ROAD SAFETY AUDIT

EXISTING ROAD

Summerland Way / Imbreys Road Intersection,
Sherwood

Kyogle Council

Photo No. 8: Sight distance west from Imbreys Road

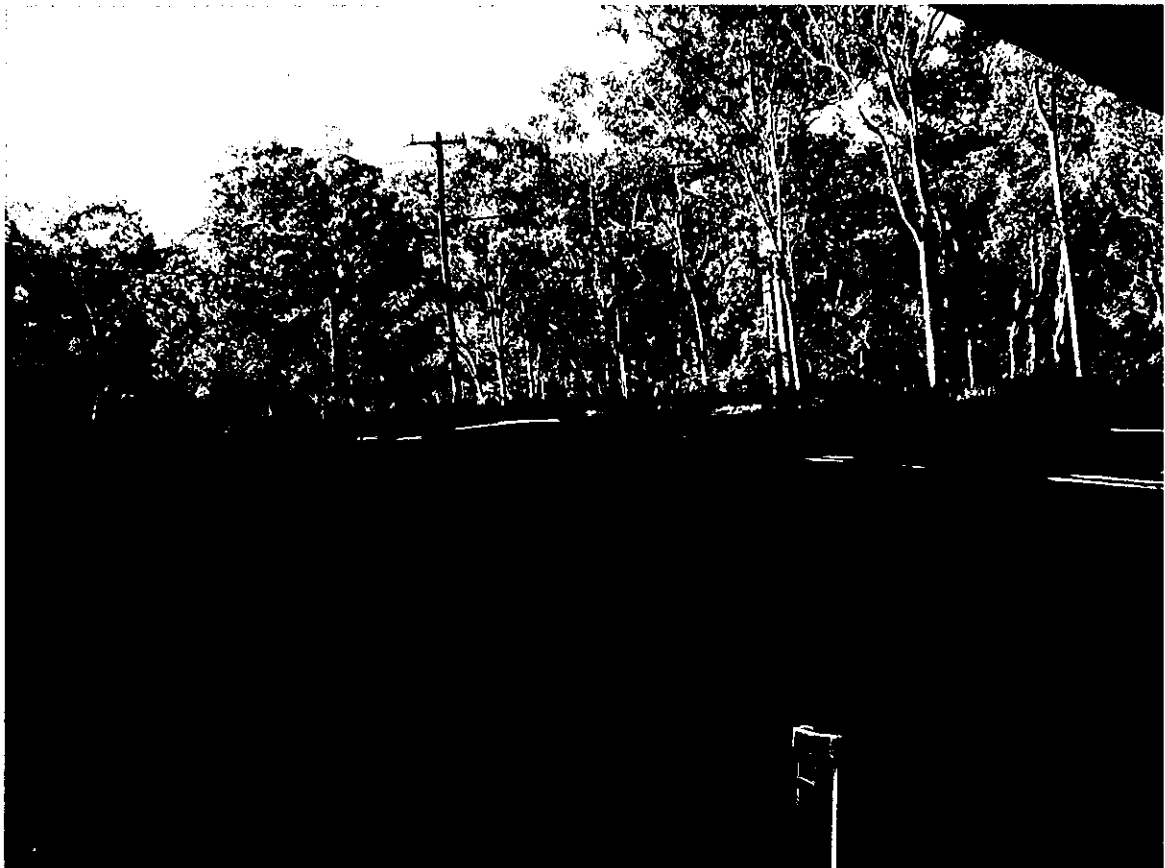
Number	Description	Risk Rating
01	<p>Sight distance from Imbreys Road – west</p> <p>Sight distance to the west is poor.</p> <p>There is a risk that vehicles exiting Imbreys Road could collide with through traffic. Or through vehicles from the east could collide with right turning traffic.</p> <p>Refer to Photo No. 8.</p>	<p>Frequency: Occasional</p> <p>Severity: Serious</p> <p>Risk: </p>
02	<p>Approach sight distances on Summerland Way</p> <p>Sight distance from both directions is just adequate.</p> <p>There is a risk that approaching vehicles, especially heavy vehicles and at night, will not see stopped or turning vehicles in sufficient time to stop, resulting in a collision.</p>	<p>Frequency: Occasional</p> <p>Severity: Serious</p> <p>Risk: </p>
03	<p>'Intersection Ahead' signs on Summerland Way – no distance</p> <p>There is no distance shown on the 'Intersection Ahead' signs on Summerland Way, in the approach to the intersection.</p> <p>There is a risk that through vehicles could misjudge the proximity of the intersection and collide with turning traffic.</p> <p>Refer to Photo No. 2.</p>	<p>Frequency: Improbable</p> <p>Severity: Serious</p> <p>Risk: Medium</p>

The sight distance from Imbreys Road to the west is inadequate. Approach sight distance from both directions on Summerland Way is just adequate. However, there is a high percentage of heavy vehicles on Summerland Way which require a longer stopping sight distance.

- Imbreys Road could be widened and sealed for a short distance to provide for two lanes
- An 'Intersection Ahead' sign should be provided in Imbreys Road
- Road edge guide posts should be provided on Imbreys Road in the approach to the intersection
- Advance warning signage on Summerland Way could be provided to improve the visibility of the intersection
- Distances could be added to the 'Side Road Intersection' signs in the approach to the intersection
- If the intersection were to be sealed, the Summerland Way edge lines could be turned in to Imbreys Road to improve the visibility of the intersection
- Vegetation in Imbreys Road, in the vicinity of the intersection, could be pruned or removed to improve sight distance.
